Re: D&C Partners Response to WDNR's June 3, 2020 Correspondence
5005 S. Packard Avenue
Cudahy, WI

Thank you for your June 3, 2020 letter in response to the Site Investigation Report / Remedial Action Options and Design Report (SIR/RAODR) submitted to the WDNR on April 21, 2020. Your letter denied our request for approval of the Site Investigation Report for the Superior Health Linens Site. On behalf of D&C Partners, LLC (D&C Partners), St. John – Mittelhauser & Associates, Inc., a Terracon Company (SMA), requests a meeting with you and your program supervisor to discuss the comments in your letter and the responses that we are providing below.

Attachments: Revised Figure 12

FIGURE
 12

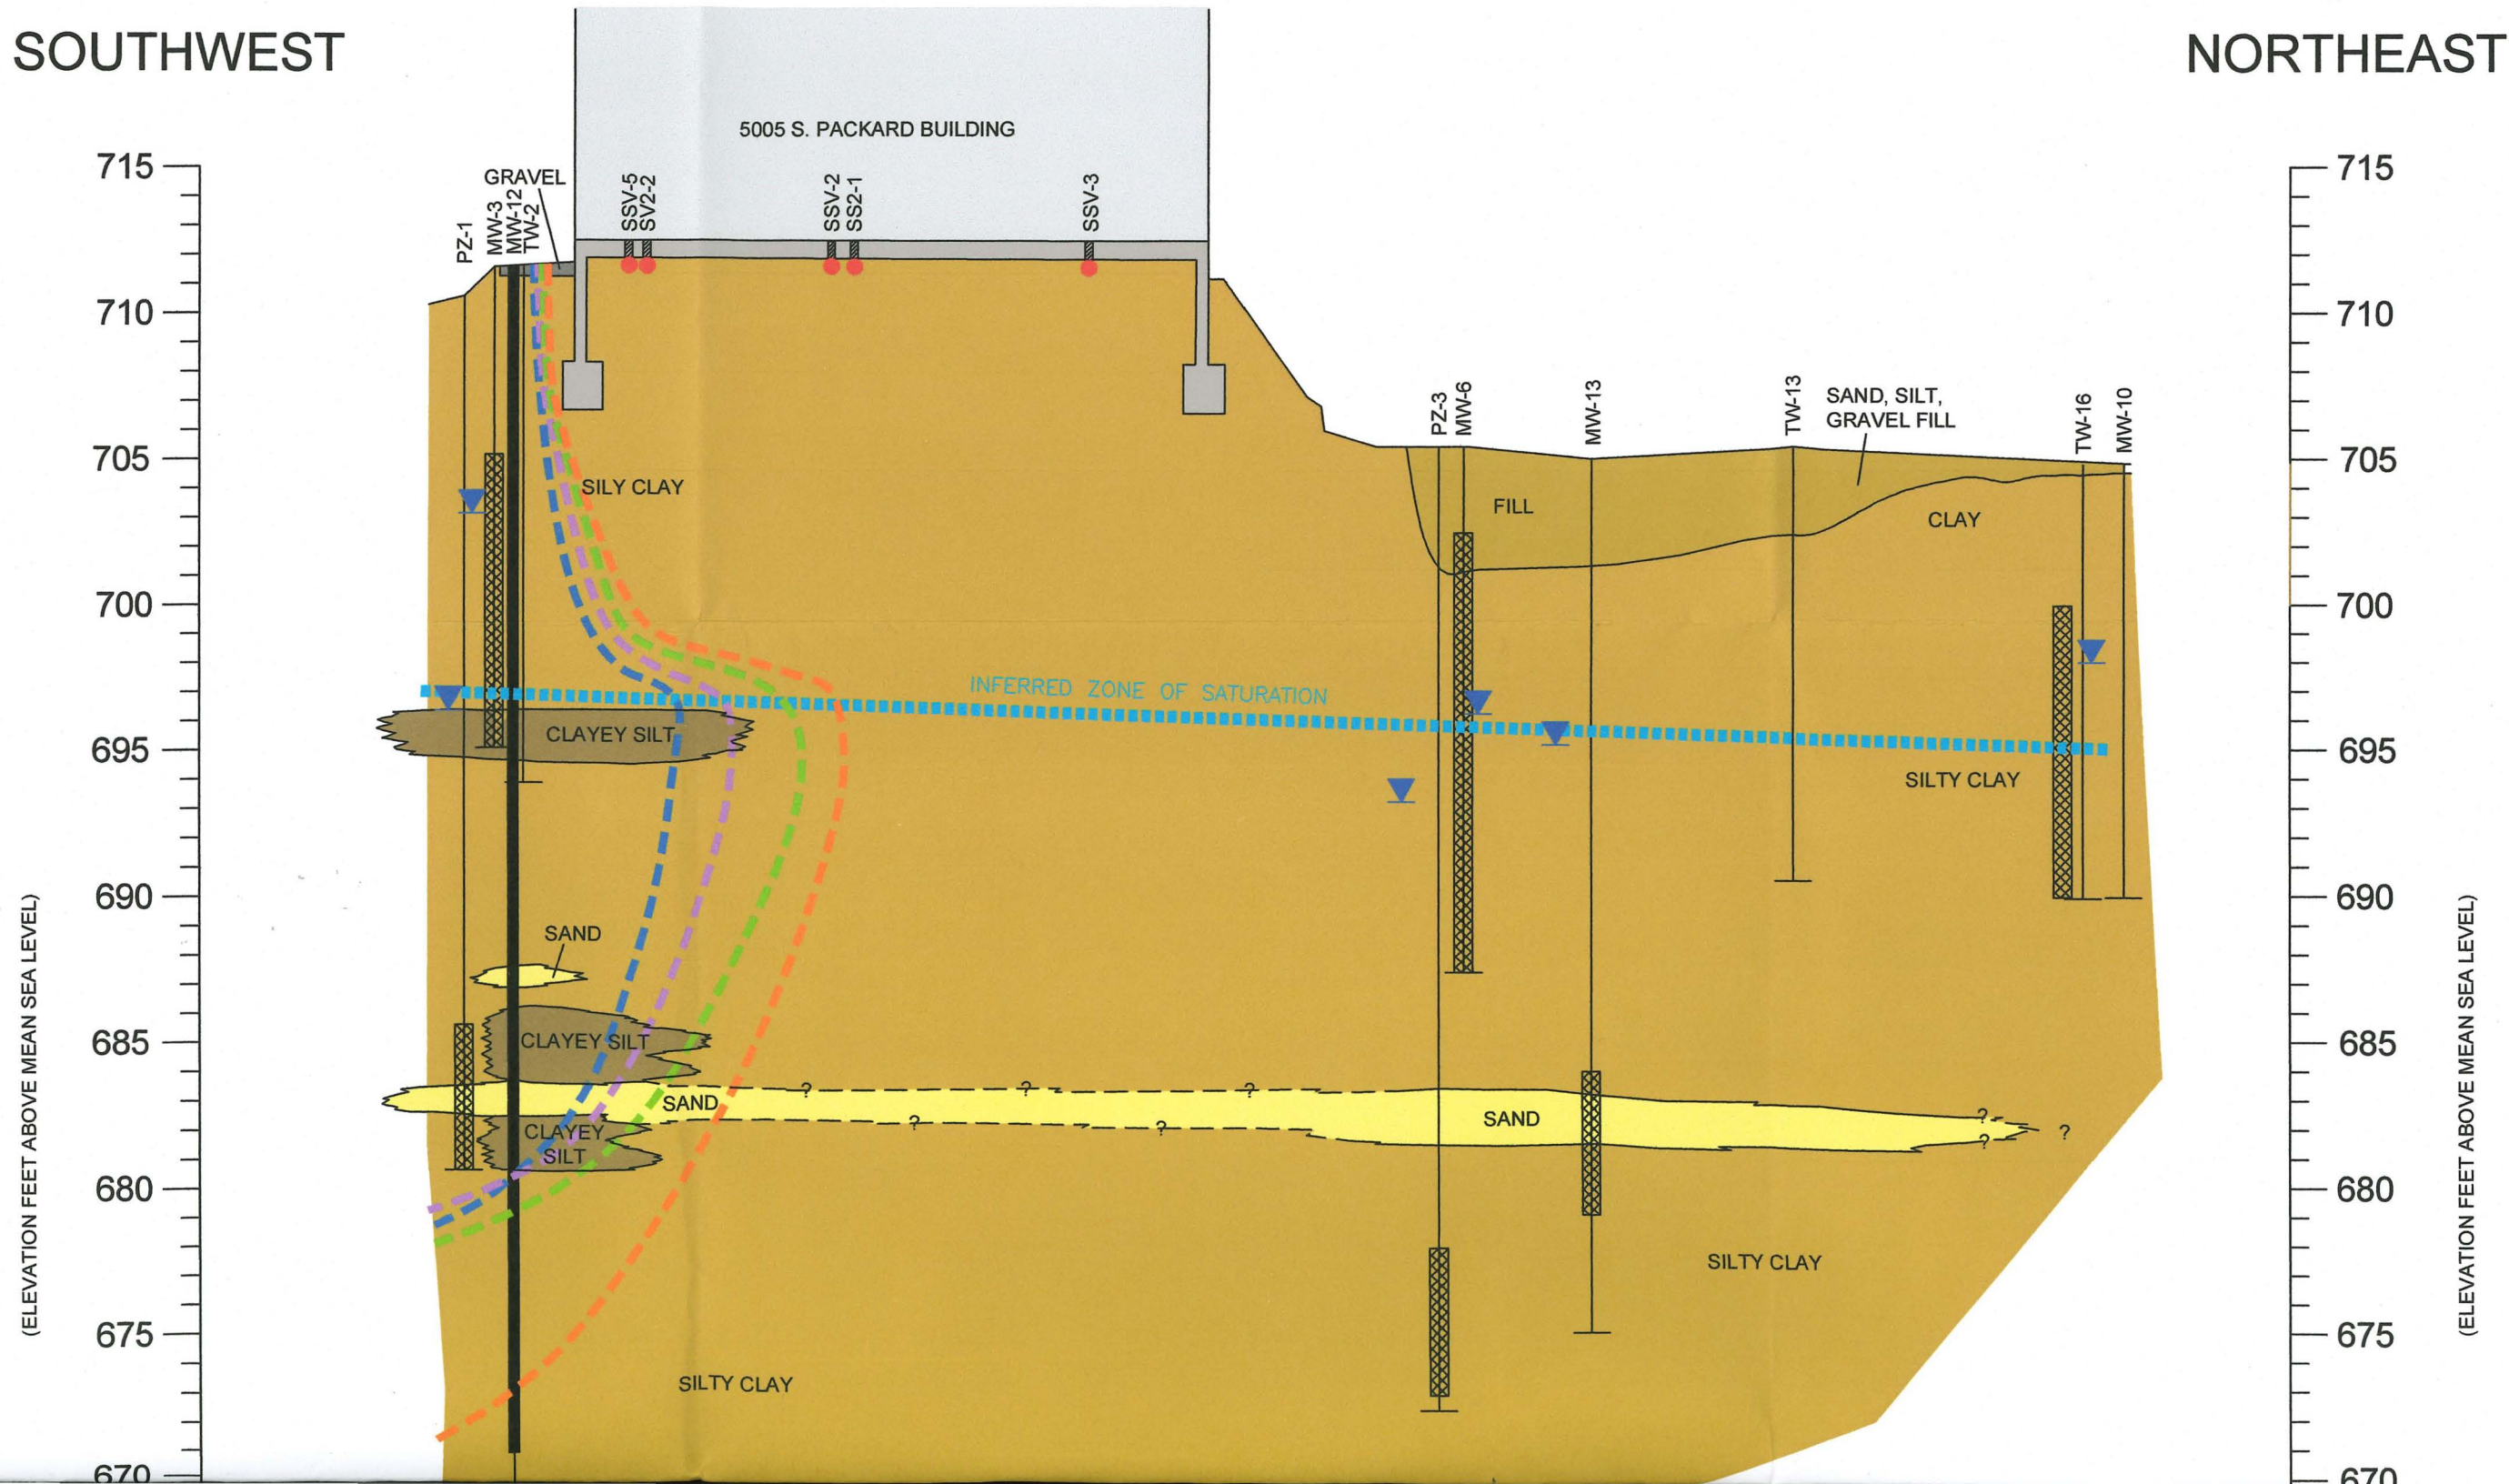
Cross section C-C', Figure 12 does not illustrate the downgradient extent of this contaminate plume and it is not included groundwater plume map, Figure 23. Based on the increased concentrations found in MW-6, there appears to be an additional unknown source of TCA. 1,4 Dioxane is known to be a stabilizer of chlorinated volatile organic compounds (CVOC), including TCA and maybe commingled with the TCA plume. Additional groundwater investigation activities may be necessary to define the degree and extent of contamination.

- 4) Historic TCA concentrations appear to increase from the potential source area identified near the southwest corner of your building and MW-2 downgradient to MW-6. This plume is missing from cross sections, maps, and discussions in your report. Also, sub-slab vapor samples and soil gas sampling detected TCA, Tetrachloroethane (PCE), Trichloroethane (TCE) and other volatile organic compounds. Based on this information it appears that areas beneath your building may be acting as source of groundwater and vapor contamination. Your subsequent investigation activities should attempt to define the degree and extent of soil, groundwater and vapor contamination beneath your building.**

Figure 23 depicts the groundwater plume within the 30-foot sand seam. MW-6 is screened above the sand seam, in the silty clay. The analytical results of the groundwater samples collected from MW-13, which is screened in the sand seam,

indicated 1,1,1-TCA was below the laboratory reporting limits for all five groundwater sampling events. Therefore, there is no plume of 1,1,1-TCA on cross-section C – C' (Figure 12).

The sub slab soil gas analytical results identified that one of the samples had no detectable VOC results and the other samples identified the presence of two (2) VOCs above the reporting limits of the laboratory equipment in one sample (SSV-3). The VOCs included 1,1,1-TCA at a concentration of 79.1 ug/m³ and TCE at a concentration of 1.1 ug/m³. Both were below their respective Target Sub-Slab Vapor Risk Screening Level of 2,200,000 ug/m³ and 880 ug/m³ respectively. Given the concentration of CVOCs within the source area, and its proximity to the western edge of the building footprint, the presence of trace amounts of 1,1,1-TCA and TCE are not surprising. Figure 12 (Cross Section C – C') has been updated to show the projected location of the sub slab soil gas samples and the inferred extent of contaminants exceeding the protection of groundwater RCLs. The updated figure is attached to this correspondence.
